Addendum #1 - Bid Package #6929-07

Project Name: Lincoln Public Schools District Office
5901 'O' Street
Lincoln, NE
Project No.: 11065
Issued: August 3, 2012

08/03/2012	SHEET
M102	ATTACHMENT NO.
M3	TSM

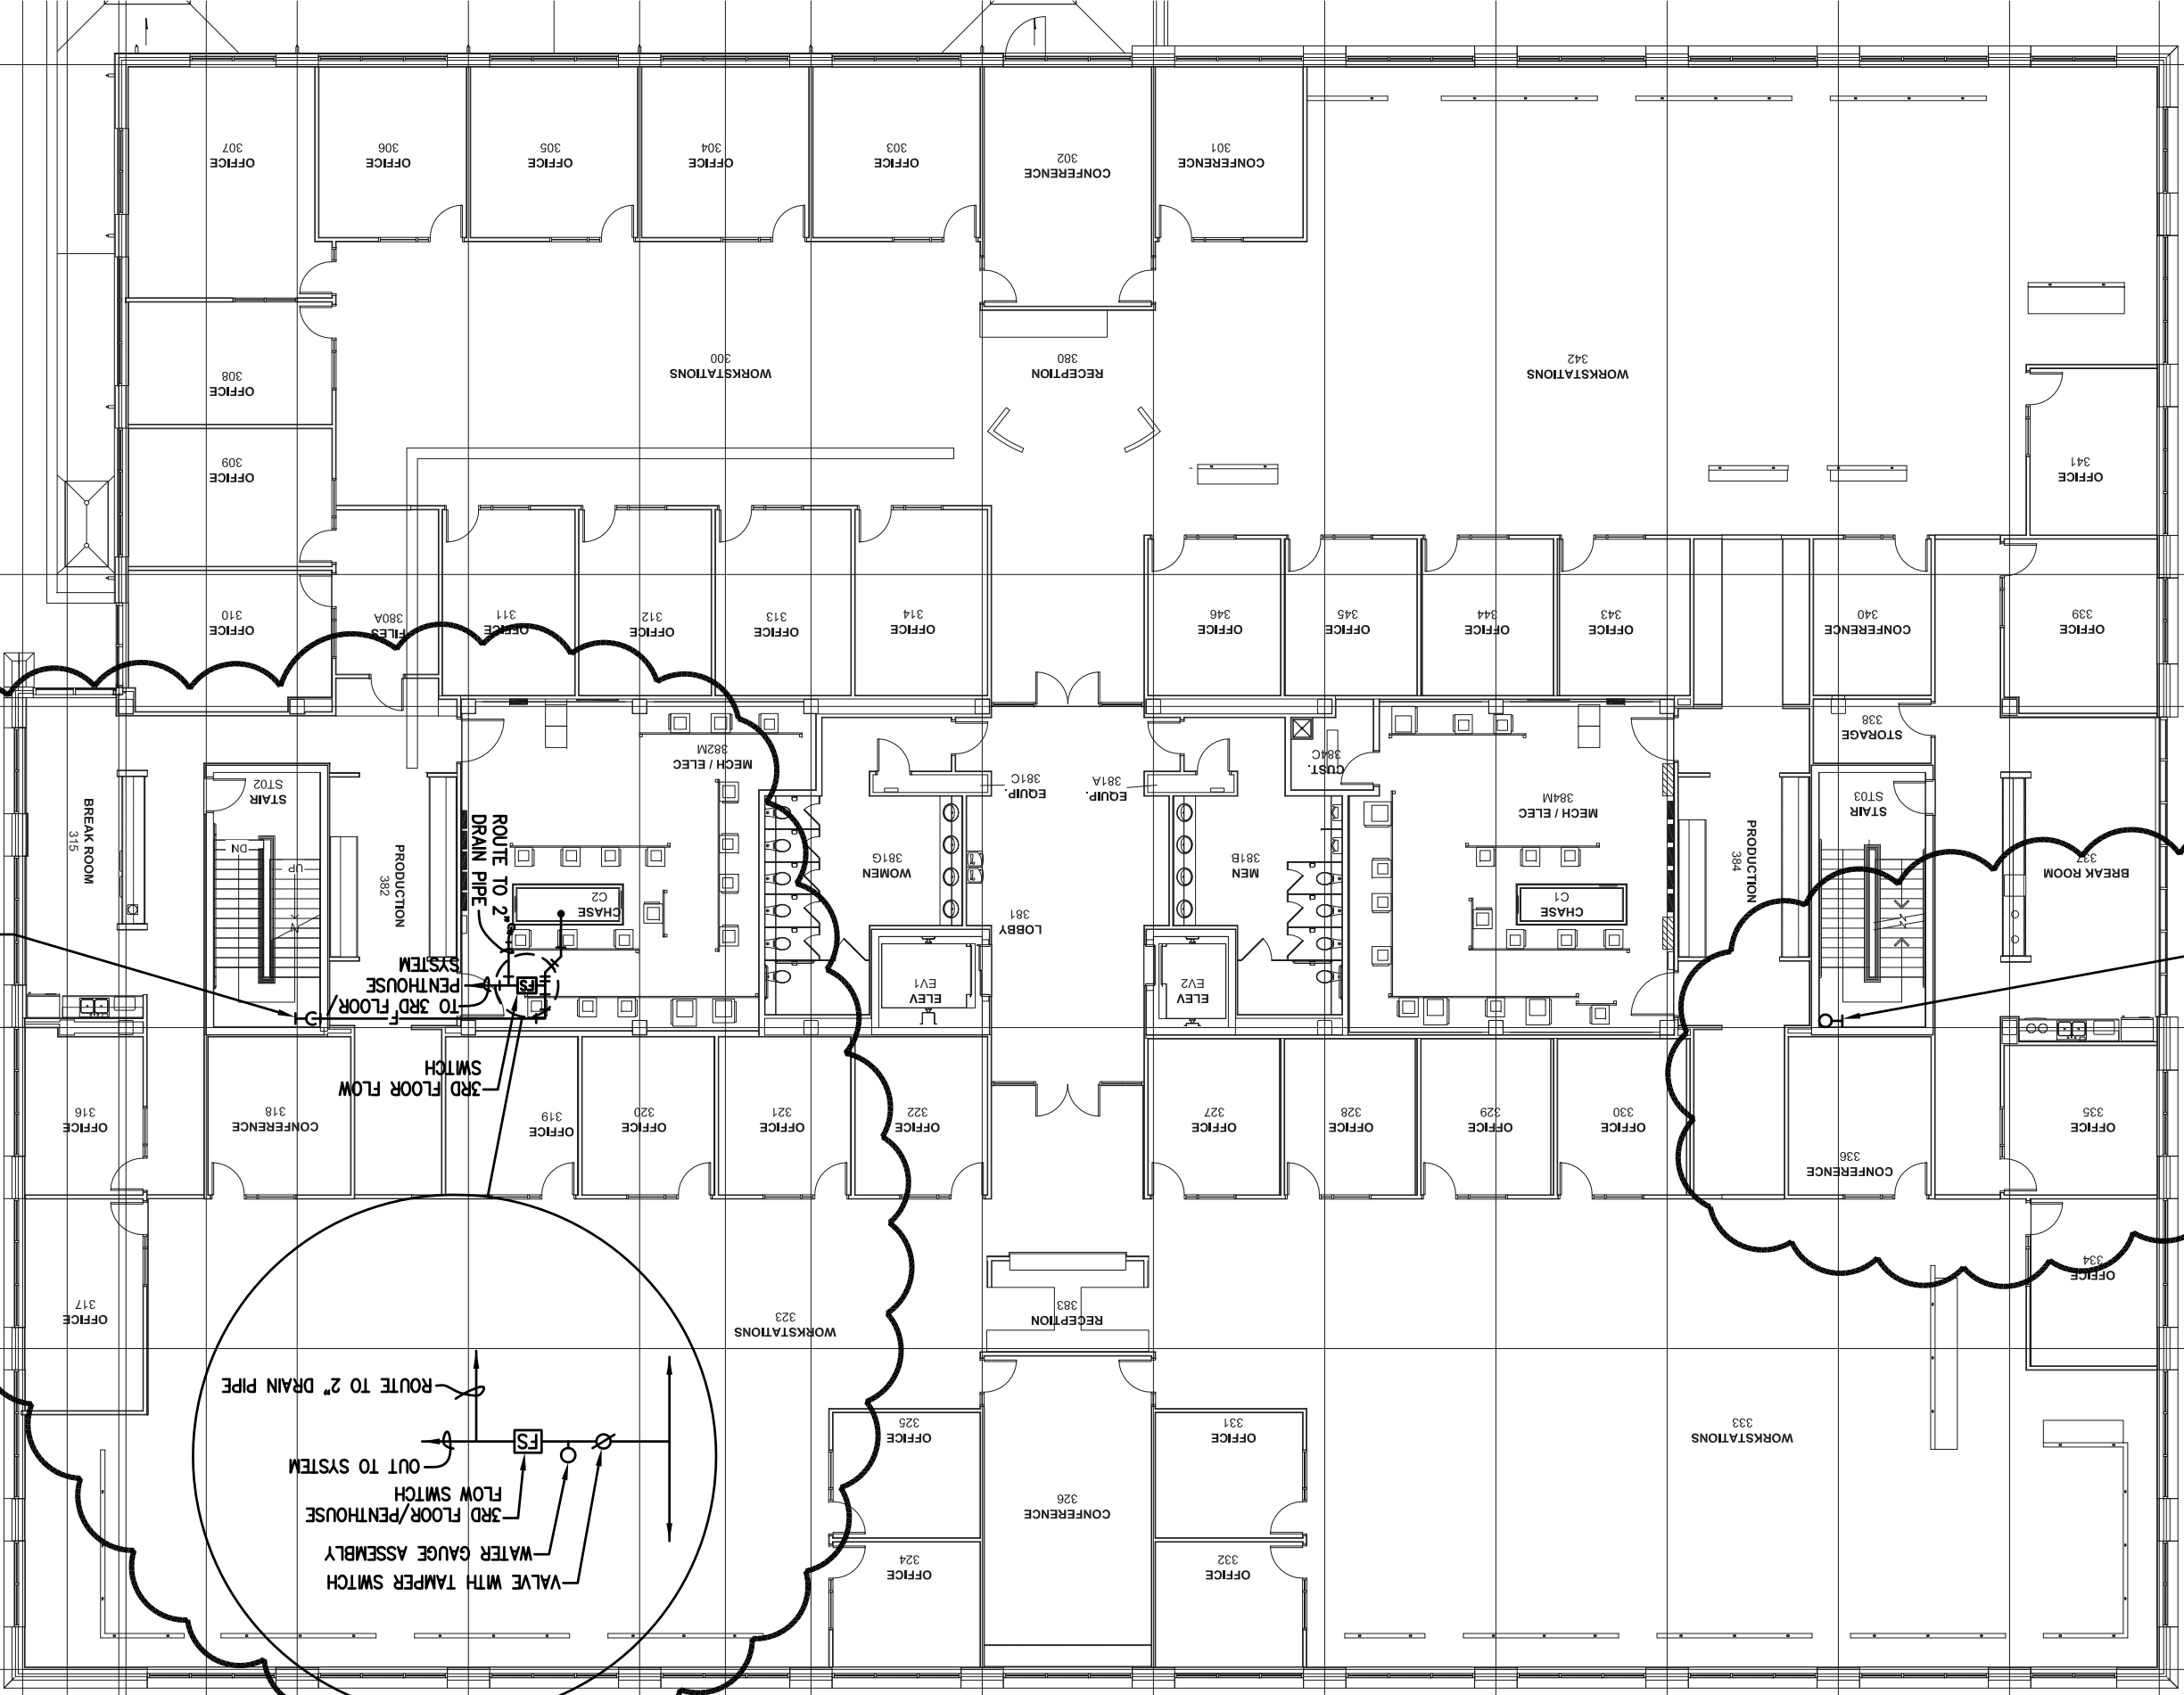
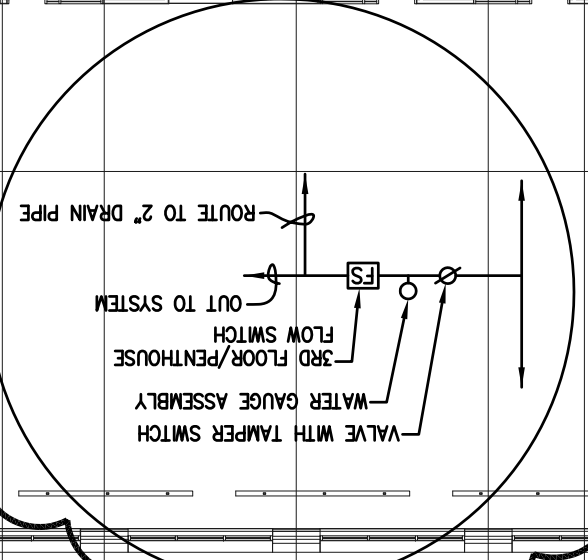
- ADD 1-17.** Refer to Sheet M102 – Second Floor Plan – Mechanical
- A. Refer to **attachment M3** for revised fire sprinkler piping.
 - i. Provide fire sprinkler standpipe in Stair ST03 and ST02 with fire department connect on intermediate levels.

- ii. Provide 2nd floor flow switch in Mech/Elec 282M. Route test/drain to 1st floor exterior.
 - B. Refer to **attachment M5** for revised rainwater and ductwork routing due to the beam change in RFI #32

08/03/2012
 SHEET
M103
 ATTACHMENT NO.
M4
 TSM

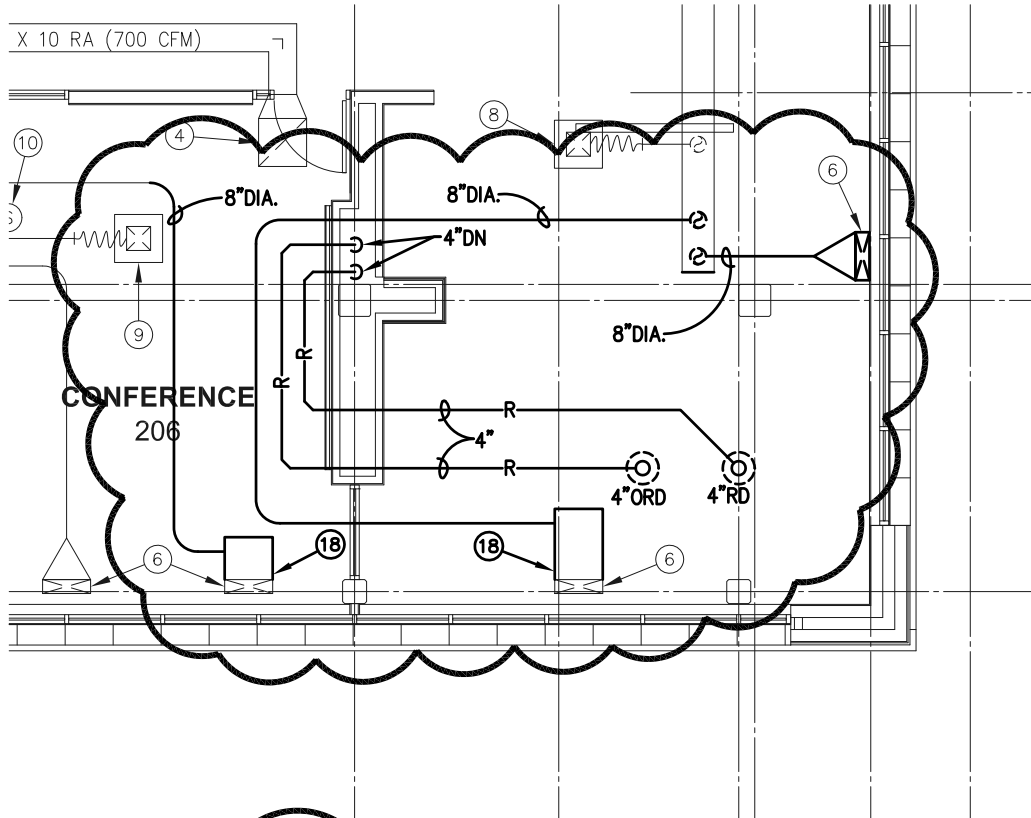
- ADD 1-18.** Refer to Sheet M103 – Third Floor Plan – Mechanical
- A. Refer to **attachment M4** for revised fire sprinkler piping.
 - i. Provide fire sprinkler standpipe in Stair ST03 and ST02 with fire department connect on intermediate levels.

- ii. Provide 3rd floor flow switch in Mech/Elec 382M. Route test/drain to 1st floor exterior.
 - iii. Reference Sheet Note 1, provide IWH-2 in lieu of IWH-1 called out.

M5

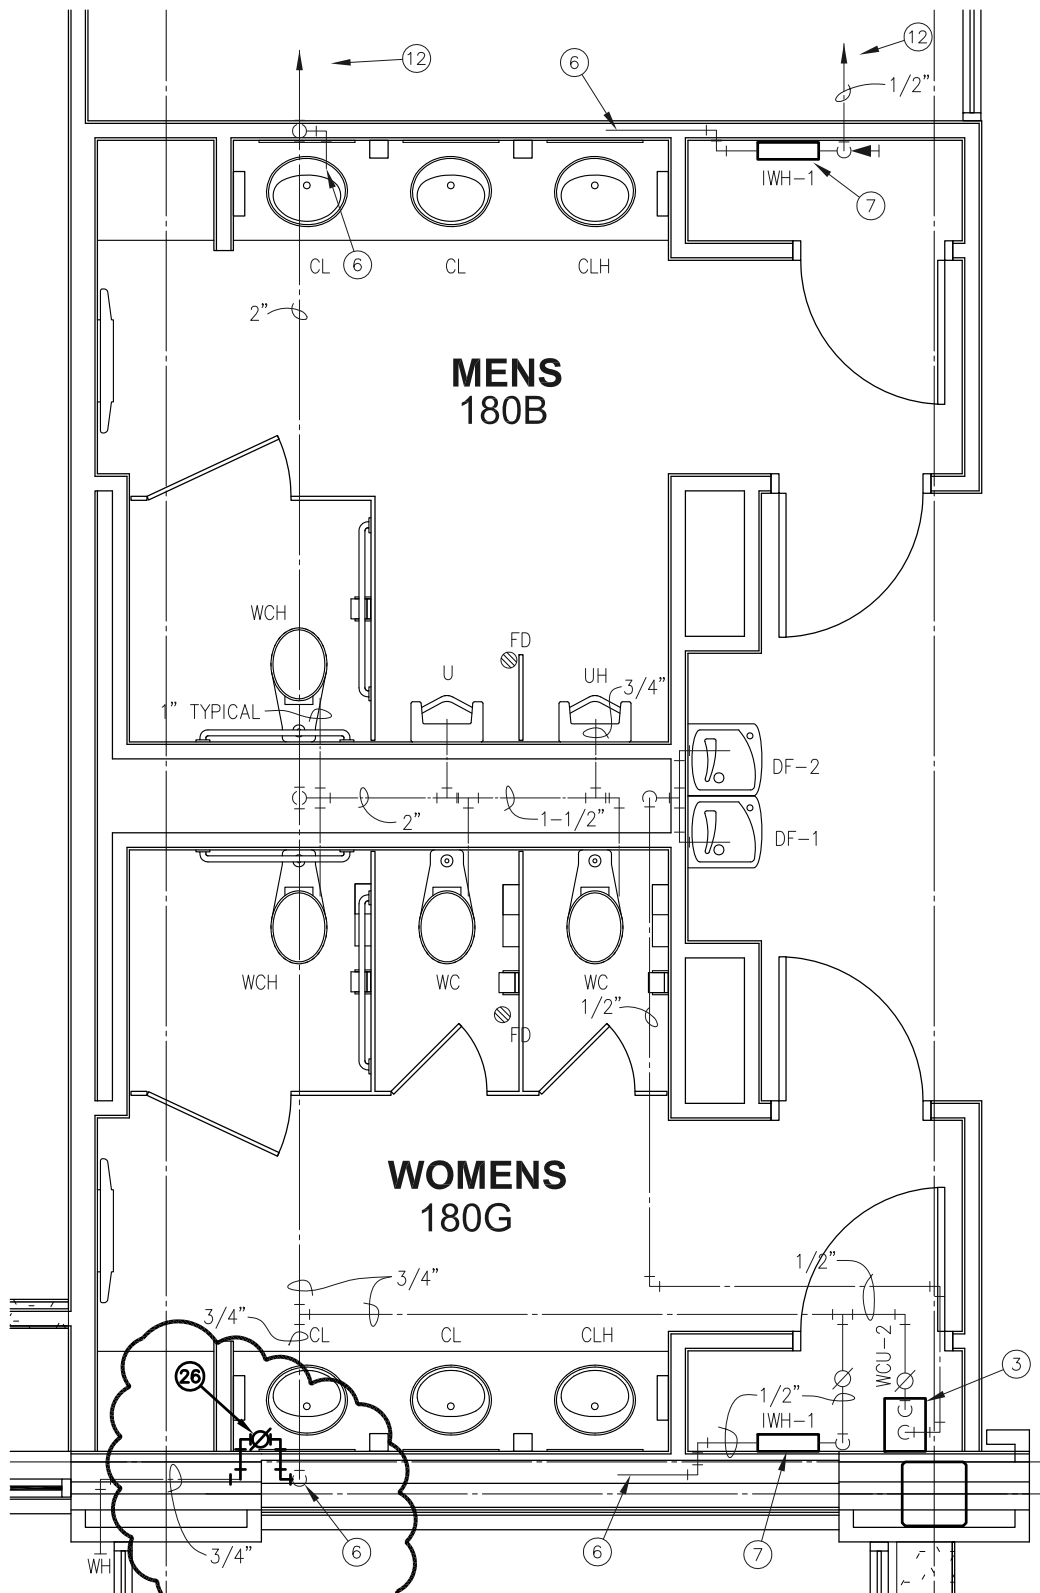
- ADD 1-19.** Refer to Sheet M202 – Second Floor Plan – HVAC
- A. Refer to **attachment M5** for the revised ductwork and rainwater routing due to the beam change in RFI 32.

SHEET
M301
 ATTACHMENT NO.
M6
 TLD

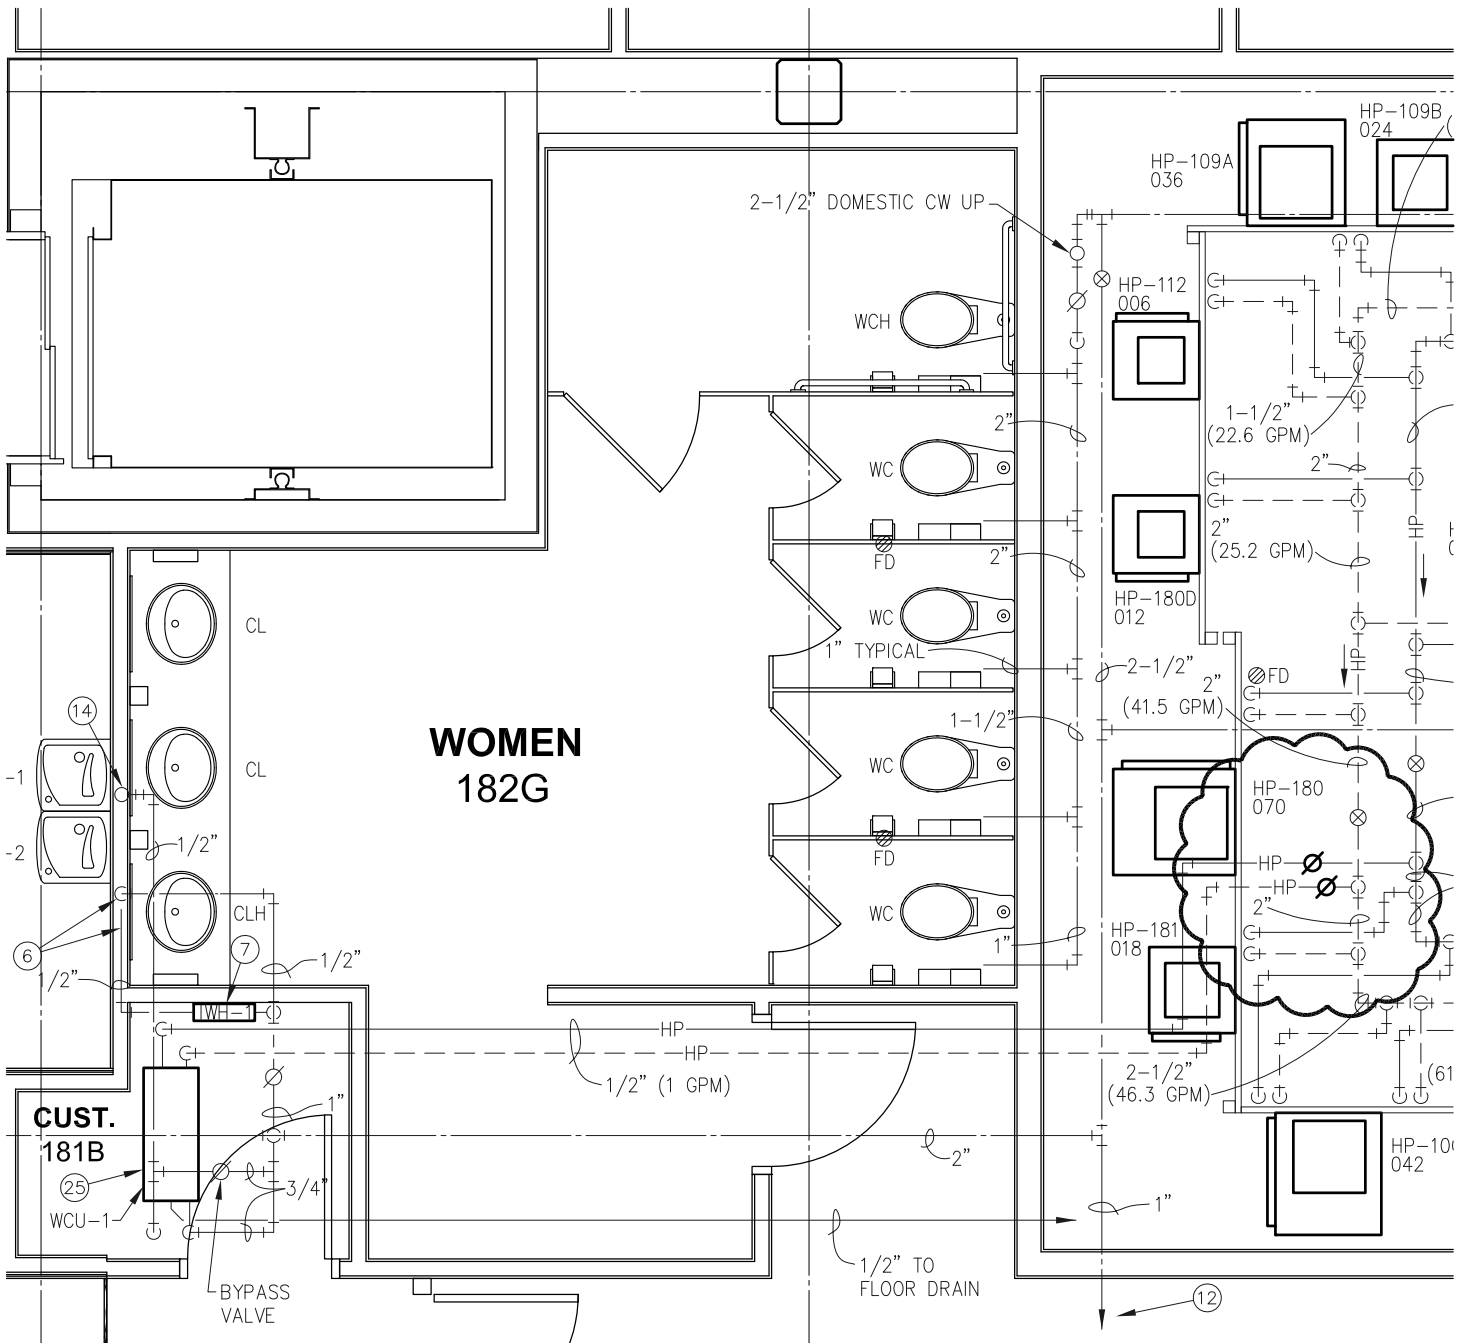
- ADD 1-20.** Refer to Sheet M301 – Partial First Floor Plan
- A. Refer to **attachment M6** for the addition of a ball valve below counter for the wall hydrant on the east side of the building.

- 26. PROVIDE BALL VALVE FOR WALL HYDRANT. VALVE TO BE LOCATED UNDERNEATH COUNTER.
